PROJECT NAME: LPC PROPERTY: LITTLEFISH

Subject: Littlefish Design/8425 Main Street; Site Plan Review #2; site plan dated 9/17/18, and revised 3/11/19.

Subject: Littlefish Design/8425 Main Street; Administrative Site Plan Review #1; site plan dated 9/17/18.

**Regarding: Littlefish Design/8425 Main Street
Site Plan Review #1**

C-2.0

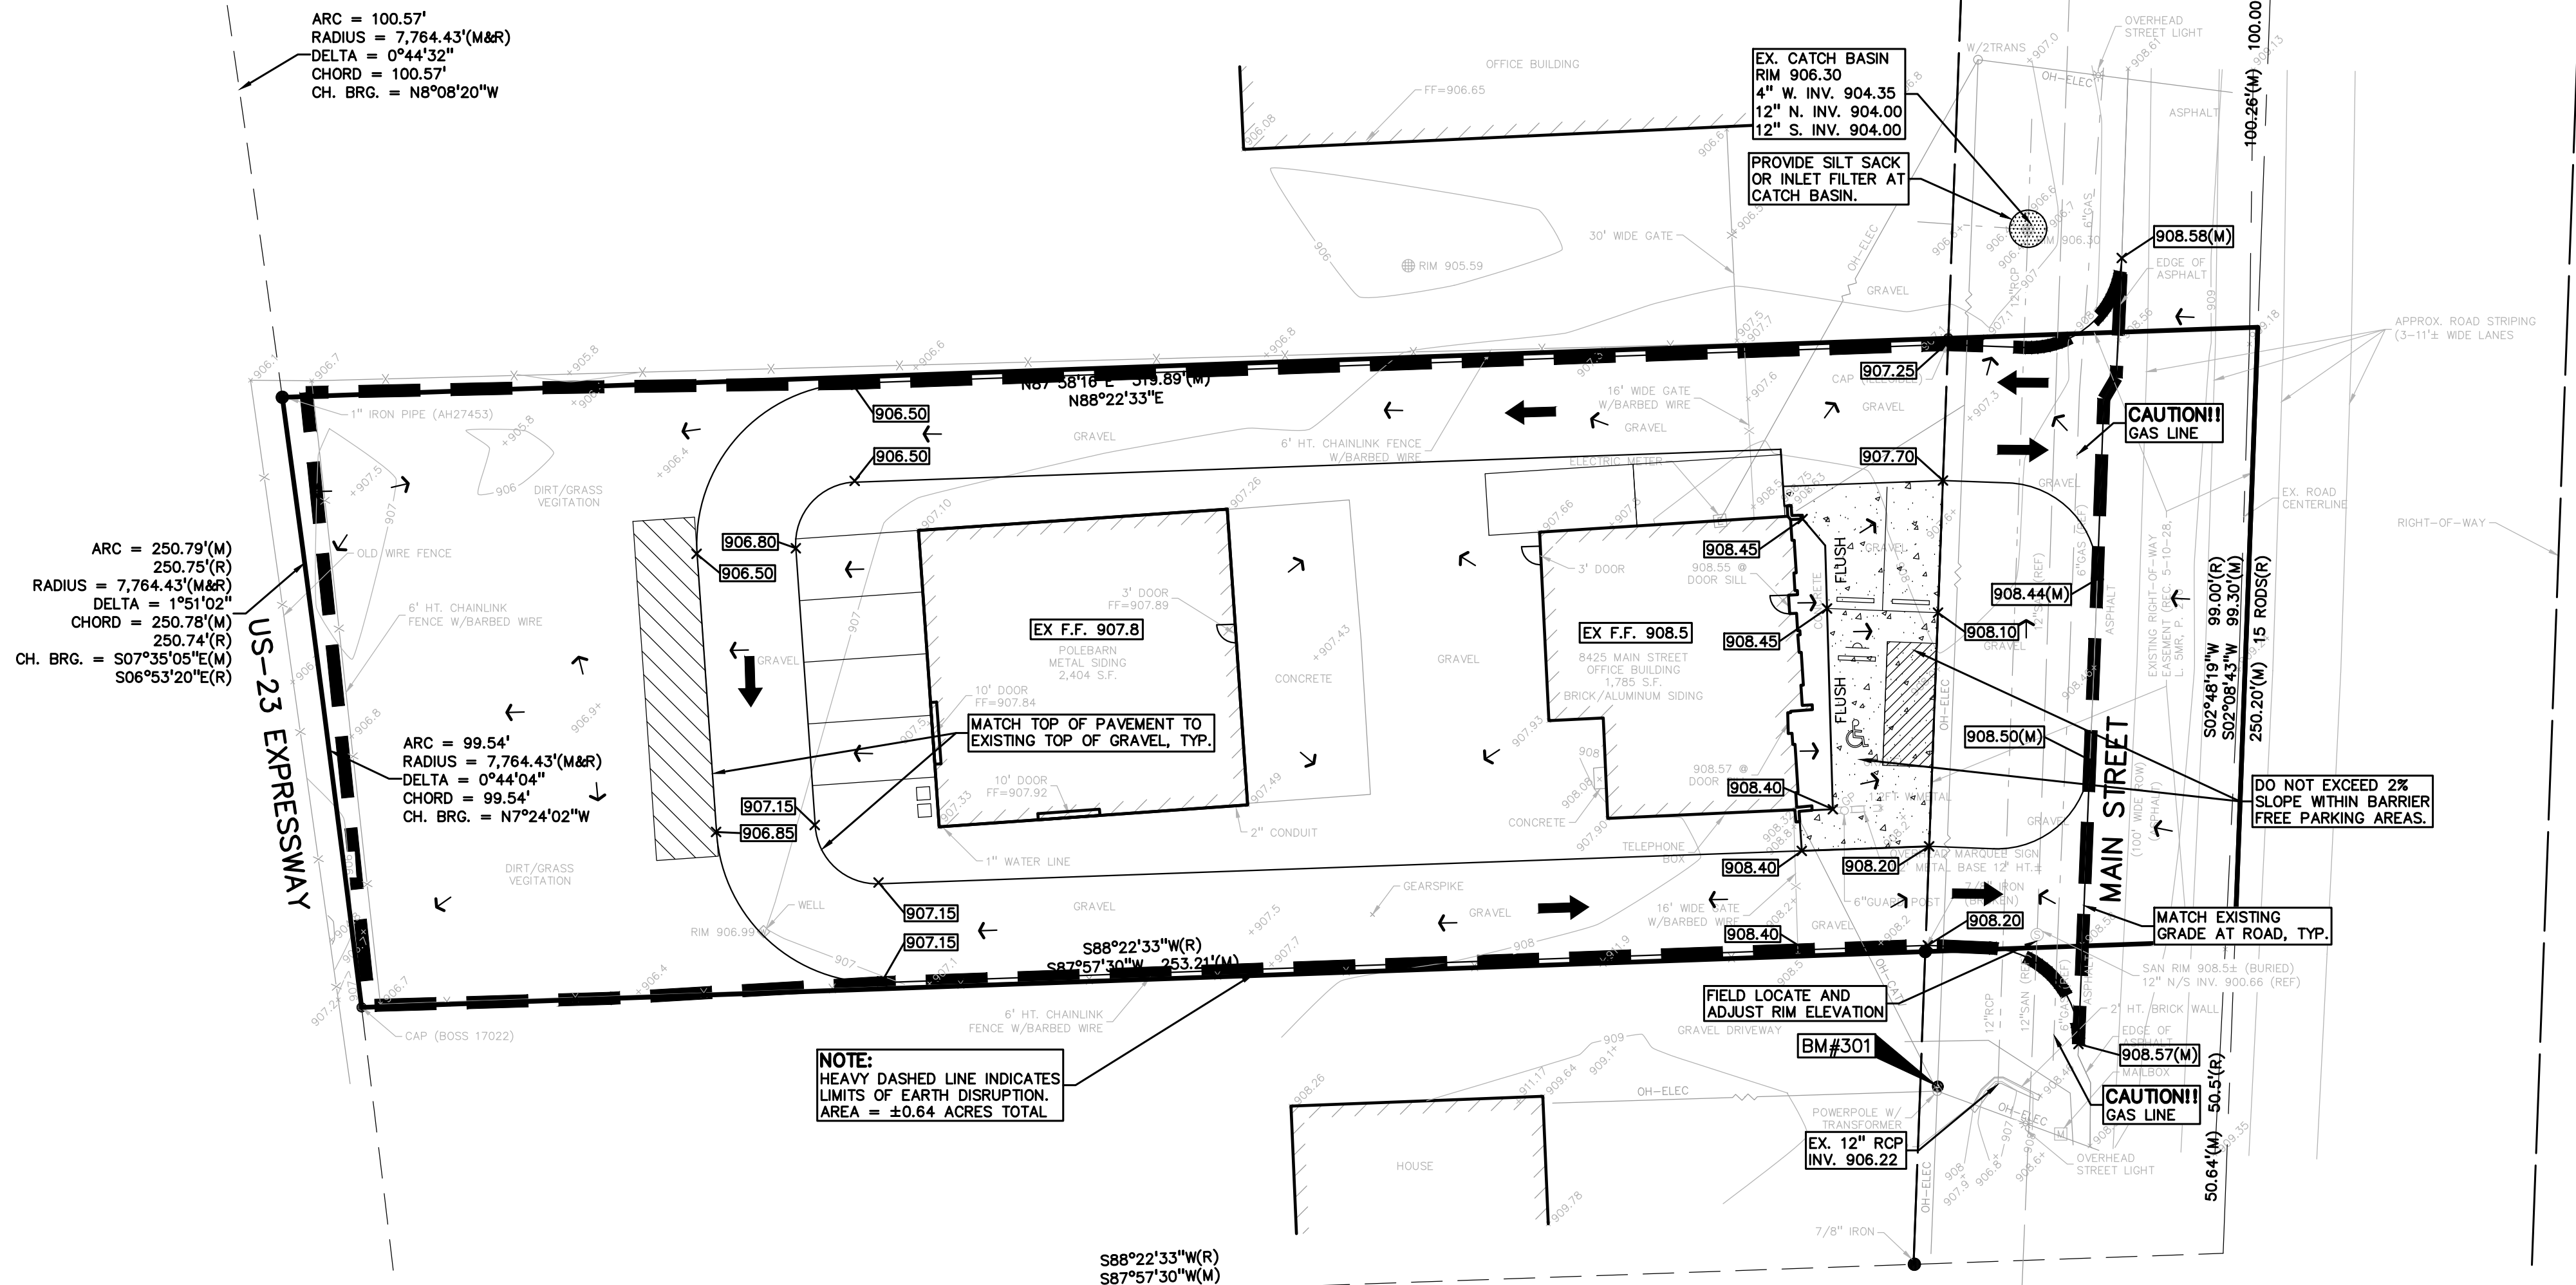
3. **Pedestrian Circulation.** The site plan indicates a sidewalk on the east side of the office building. The width of the sidewalk is noted at 5 ft.
4. **Vehicular circulation.** The site has two (2) existing access drives placed on the north and south ends of the frontage along Main Street. The plan proposes a one-way circulation path with vehicles entering from the north access drive and exiting from the south access drive. The circular access drive is to be constructed of asphalt with the approaches to be "heavy duty asphalt". The plan notes that no 'permanent pavement markings' will be provided. The plan shows two-way drive on the north and a one-way exit on the south with one-way circulation around the building. In a meeting with the Washtenaw Road Commission, one-way circulation was discussed. In order to prevent vehicles from entering/exiting on the wrong approach, we recommend that pavement striping be provided and one-way circulation movement. We understand the request for a two-way entrance in the north and defer to the Washtenaw County Road Commission and the Township Engineers opinion on the north driveway. The revised plan includes 3 parking spaces parallel to the building façade. The area between the parking spaces and the edge of pavement on Main Street is to be provided with low ground cover, as required by the County. Any work done within the right-of-way would require permitting and approval from Washtenaw County Road Commission.

5. **Parking.** Parking requirement for professional offices is one (1) space per 200 square feet of gross floor area. The site plan notes 9 spaces for the 1,785 s. f. building, which meets requirements for the use. No parking is provided for the existing 2,404 s. f. barn on the rear of the property. The Planning Commission had previously conditioned approval upon provision of one additional space at the rate of 1 space per 2,000 s. f. for warehousing/storage use; however, the required space is not shown. We believe that an additional parallel space could be fit west of space number five. Further, the parking calculations data table has not been updated and still notes "5 spaces in front of building". Conflicting notes must be corrected to ensure a site plan with consistent information.

6. **Loading.** The required loading space is shown dimensioned on the west side of the barn. A truck circulation diagram has been submitted and is acceptable.

- a. The frontage cannot remain as pavement with parking spaces encroaching on the public right-of-way. The required setback for parking is 10 feet. While this is an existing non-conformity, it is an issue that can be corrected. The parking must be removed and a landscape area created between the building frontage and the property line.

- b. The circulation drives must be clearly delineated.
 - c. All areas of pavement (asphalt or concrete) and gravel need to be clearly differentiated and shown on the plan.

- d. Circulation route must be shown through pavement signage or striping.
 - e. The handicap accessible space cannot be placed in a manner that would require the right-of-way for maneuvering. The applicant was previously directed to place the barrier free space aligned north-south, with all other parking placed along the sides and rear of the building. This handicap parking space will likely be within the 10 foot required setback; however the overall nonconformity of the site will be reduced.

- a. Parking calculations noted on the site plan are incorrect. Square footage of the building cannot be reduced to determine parking needs based on "less incidental areas". Gross means entire building footprint.

- b. Parking calculations must be noted for the barn based on its use for storage, assembly etc.
 - c. The handicap accessible space must be shown as described in item 4.e, above.

- d. Dimensions of the parallel parking spaces on the north side of the building must be noted in compliance to Ordinance standards.
6. **Loading.** The required loading space is shown dimensioned on the west side of the barn. A truck circulation diagram has been submitted and is acceptable.

DRAWING NUMBER:
L-1.0

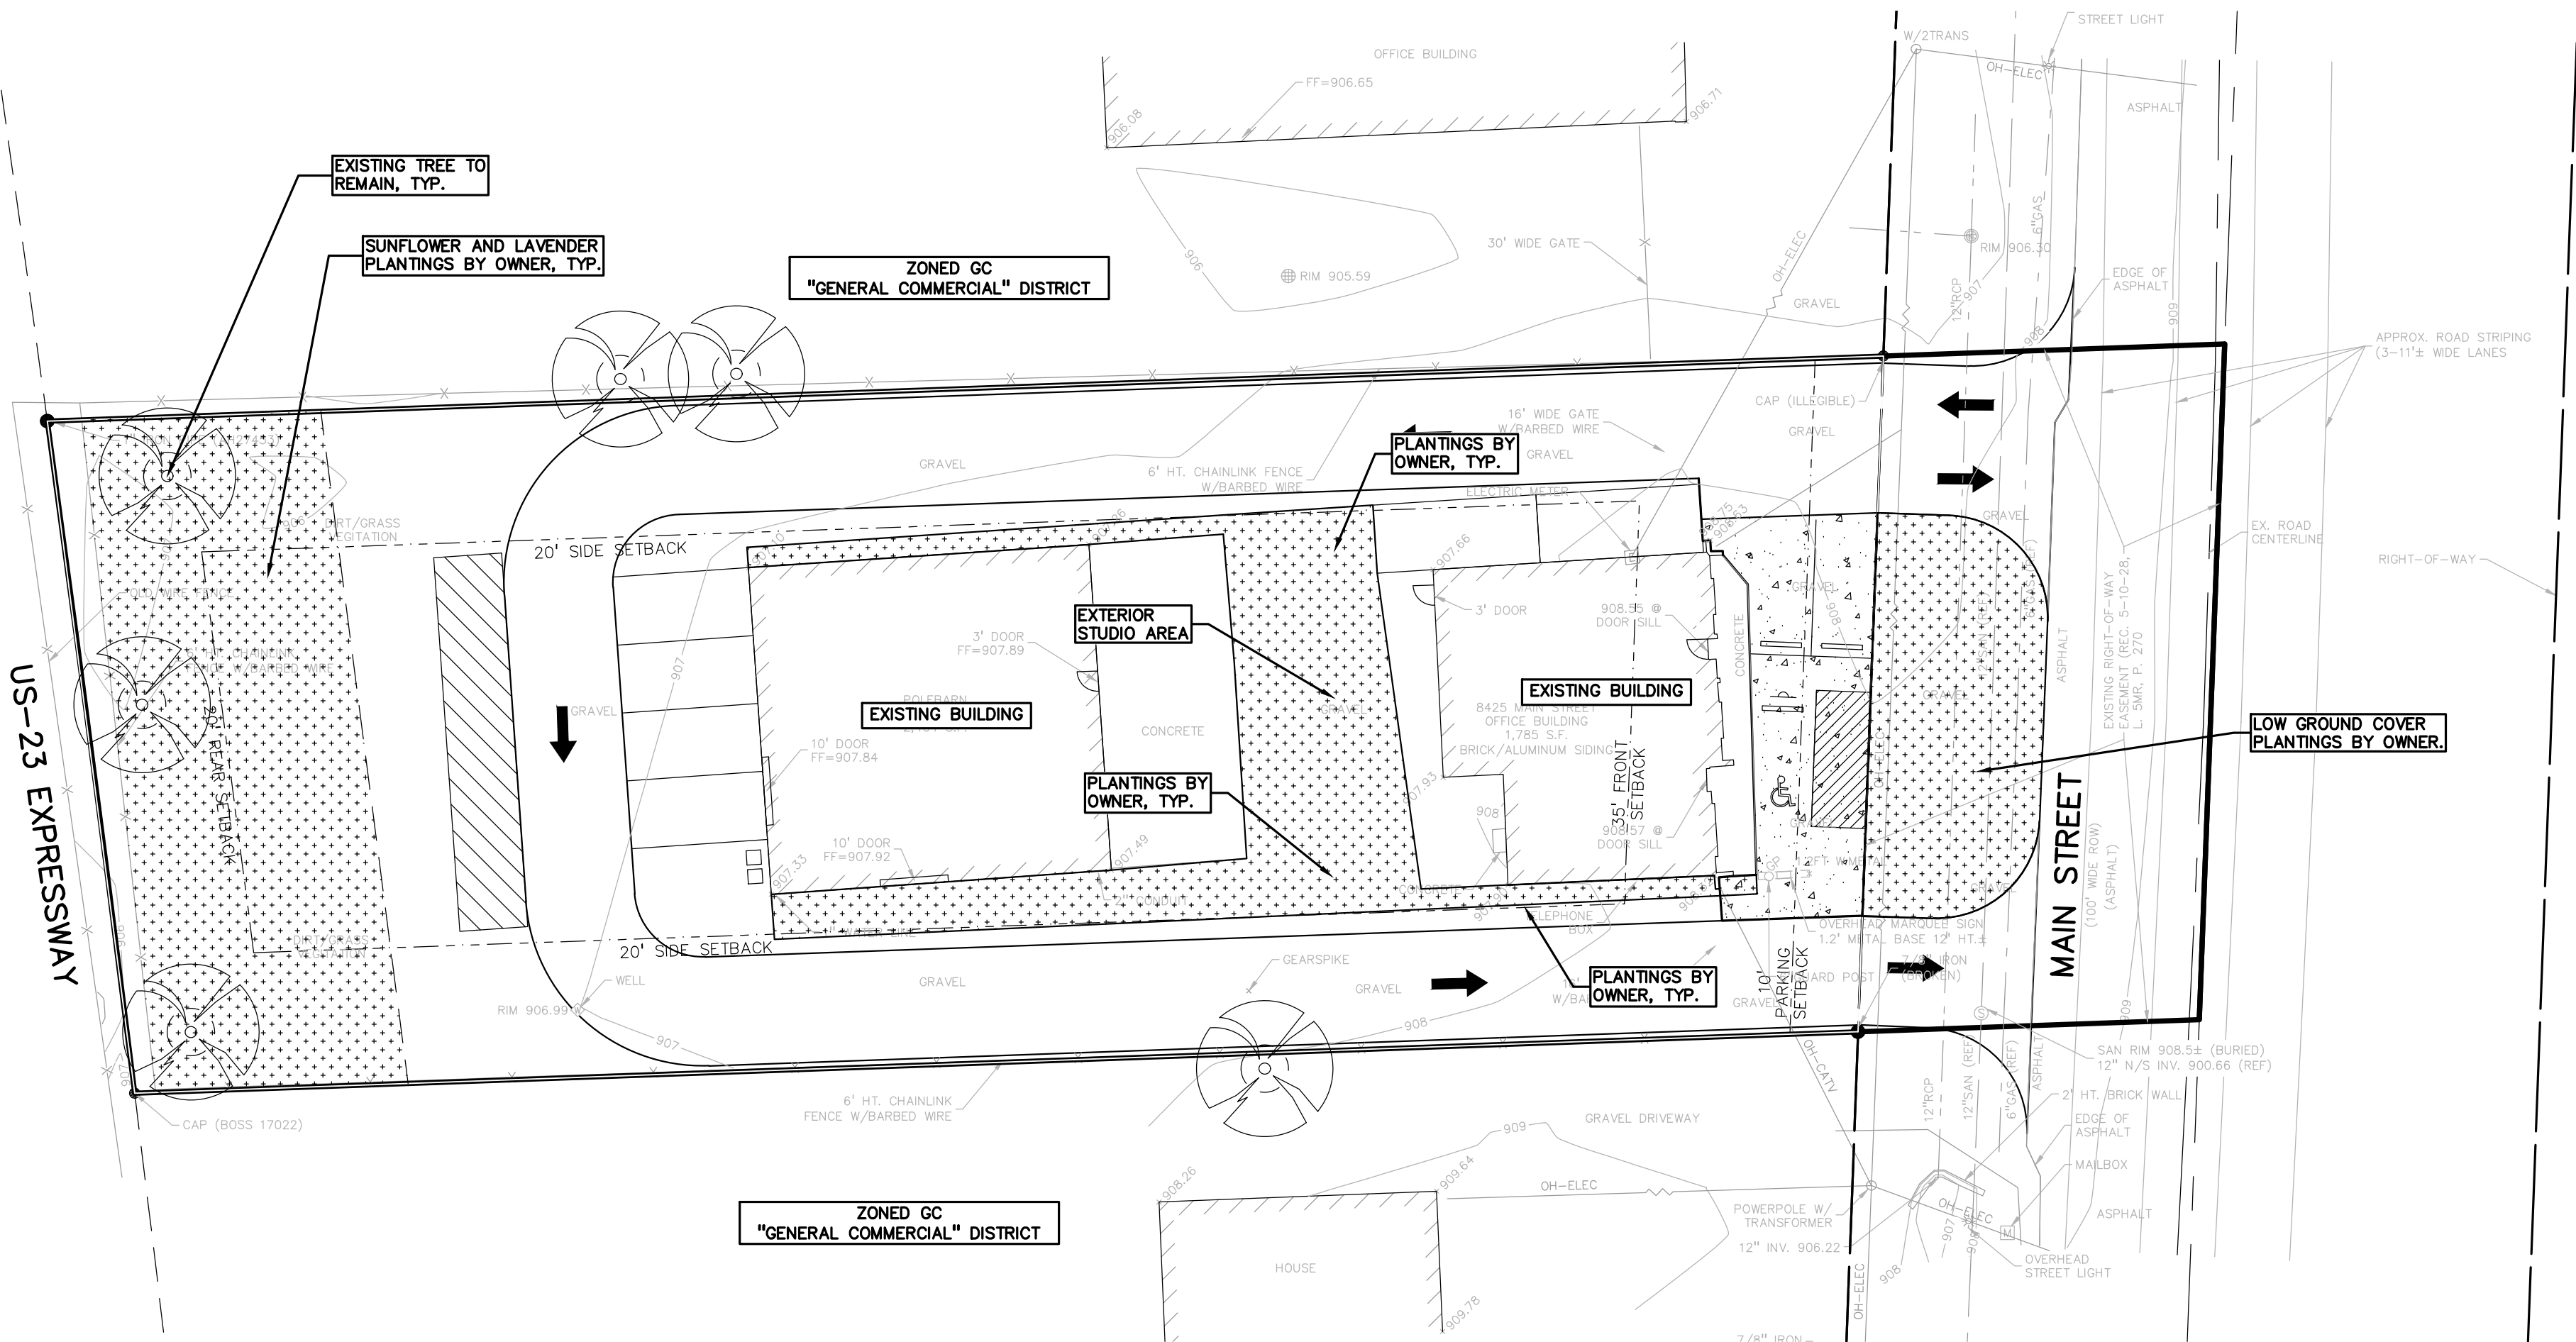
7. **Landscaping.** The site has minimal landscaping at the present time. The landscape plan indicates several landscape areas on the site with spaces marked "plantings by owner". Three trees are shown along the west property line abutting US-23, which the applicant proposes will meet the parking lot landscaping requirement of two trees. The plan includes a notation of landscape maintenance. The following items regarding

- a. The “plantings by owner” must include detailed listing of plant species, number and size at the time of planting. Proposal to plant some seasonal flowers can be noted as such; however, the landscaping should also include shrubs, trees and perennials, we would accept this information to be provided in a letter from the applicant.

- b. Clarify what is proposed as ground cover along the site’s frontage.
 - c. The plan states that landscaping will be irrigated as necessary “until they are established”. There must be a regular watering schedule to ensure long term viability of the plantings which affects the site’s appearance.

- d. Clarify the surface material for the hardscape patio area and provide details for type and color of pavers proposed. The applicant previously presented several “inspiration ideas” at the PC meeting, but the actual product to be used must be specified.

7. **Landscaping.** The site has minimal landscaping at the present time. The landscape plan proposes the installation of a new deciduous tree on the west side of the property and indicates several landscape areas on the site with spaces marked "plantings by owner". A few existing trees are shown along the west property line

- a. The landscape area along the site's frontage must be created between the sidewalk along the building frontage and the property line as discussed previously with the applicant and noted in Comment 4.a, above.

- b. The "plantings by owner" must include detailed listing of plant species, number and size at the time of planting. Proposal to plant some seasonal flowers can be noted as such; however the landscaping must also include shrubs, trees and perennials.

- c. The plan must provide for a clear separation of landscape area and drive aisles all over the site. Typically concrete curbs are required; however, the applicant had previously discussed some other alternative method of delineating the separation. As proposed, trucks circulating the site are likely to drive over the landscape areas, which is not acceptable.

- d. The plan states that landscaping will be irrigated as necessary "until they are established". This is not acceptable. There must be a regular watering schedule to ensure long term viability of the plantings which affects the site's appearance.

- e. Manufacturer's cut sheet detail for proposed table and chairs must be submitted.
 - f. Clarify the surface material for the patio area and provide details for type and color of pavers proposed.
